Rezoning Transportation Analysis

Petition Number: #2022-087

General Location Identifier: 04715204, 04715205, 04715206, 04715208

Revision Log:

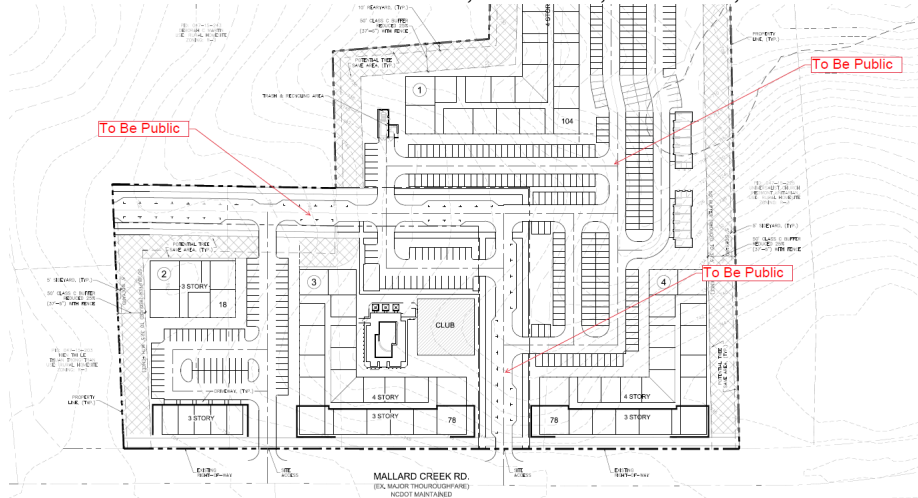
2. ~~**Traffic Study**~~:

A Traffic Impact Study (TIS) is not necessary for the complete review of this petition due to the site generating less than 2,500 daily trips. If during the permitting process the site generates more than 2,500 daily trips, then a traffic study will be required.

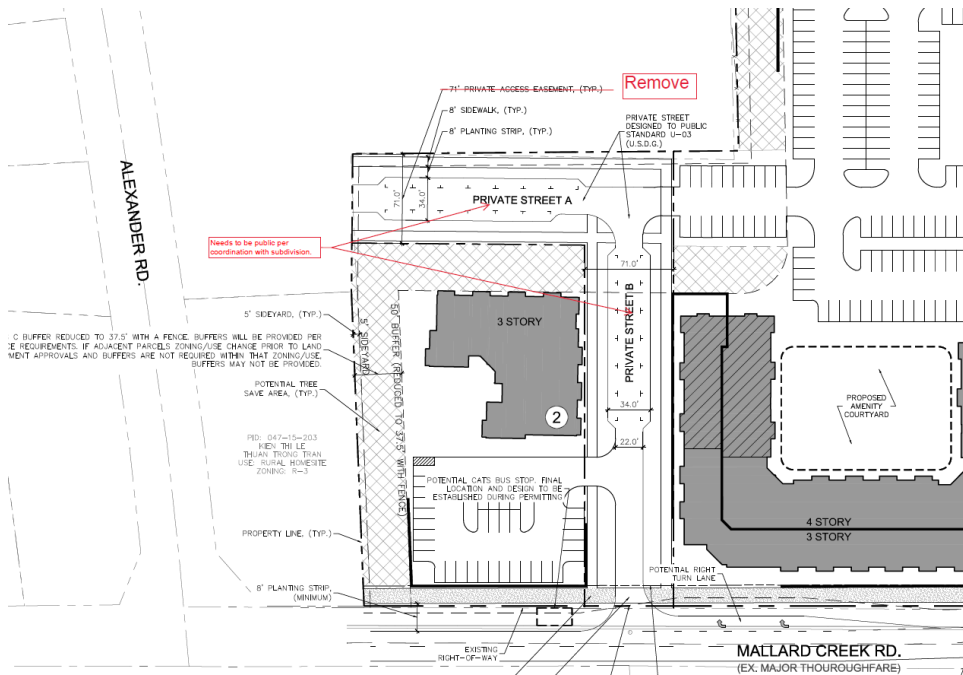
4. ~~Revise site plan and conditional note(s) to commit to constructing internal public roadways designed to the standard of CLDSM U-03 and extend the north to south roadway to Alexander Road. The site plan shall label and dimension the ROW, curb and gutter, and the sidewalk from the roadway centerline.~~

~~Clarifying comment from 12/22/2022: Private Street A and Private Street B will both need to be public streets per coordination with subdivision. Remove all references to private access easements for Private Streets A and B.~~

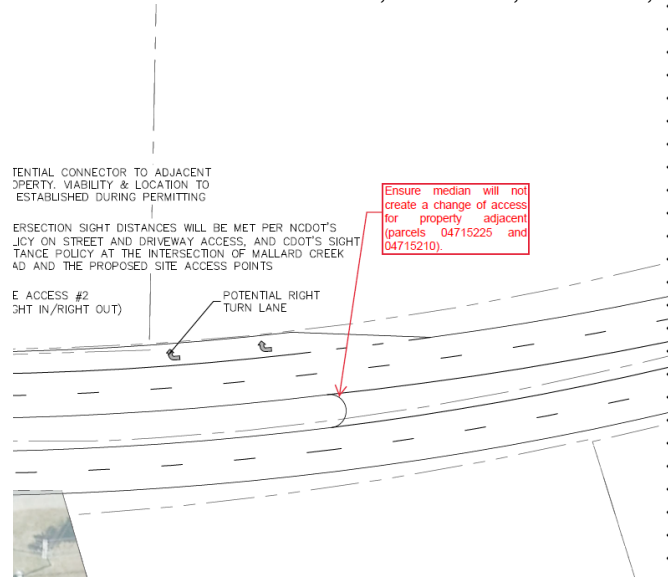
~~5. New comment from 12/22/2022: Modify median to ensure full movement for development adjacent can be retained from parcels 04715225 and 04715210. What is being proposed will create a change of access for the development adjacent to property.~~

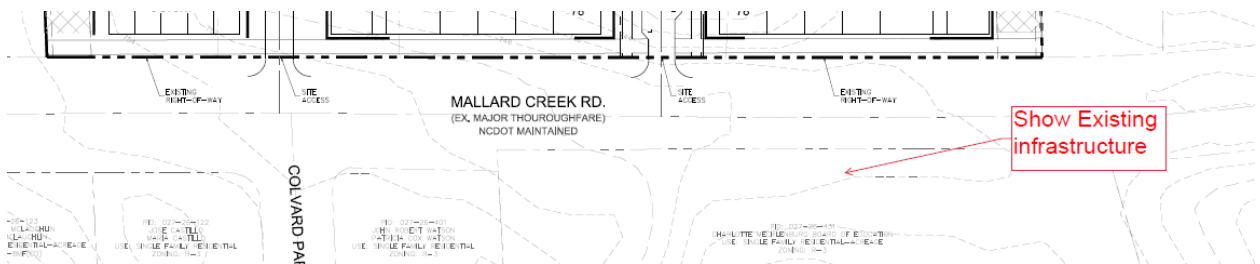
- 6. ~~The proposed dwelling units exceeds 12 per acre. Per Chapter 20 Subdivision ordinance, site plan and conditional note(s) revisions are needed to commit to construct an 8-foot planting strip, and 8-foot sidewalk along all internal public roads. The wider sidewalk also meets the Charlotte WALKS Policy.~~
- 7. ~~Revise site plan and conditional note(s) to commit to construct an 8-foot planting strip, and 12-foot sidewalk along the sites frontage per Chapter 19. The site plan shall label and dimension both items from the back of curb and gutter and road centerline.~~
- 8. ~~Revise site plan and conditional note(s) to commit to the southern site access as right in or right in/right out only. The northern site access at Colvard Park Way may be constructed as full movement. Site plan shall callout access restrictions of both site entrances.~~

~~Modify conditional note to specify that final design and location of southern driveway access will require additional coordination during permitting and may require infrastructure changes such as re-striping and/or concrete medians.~~
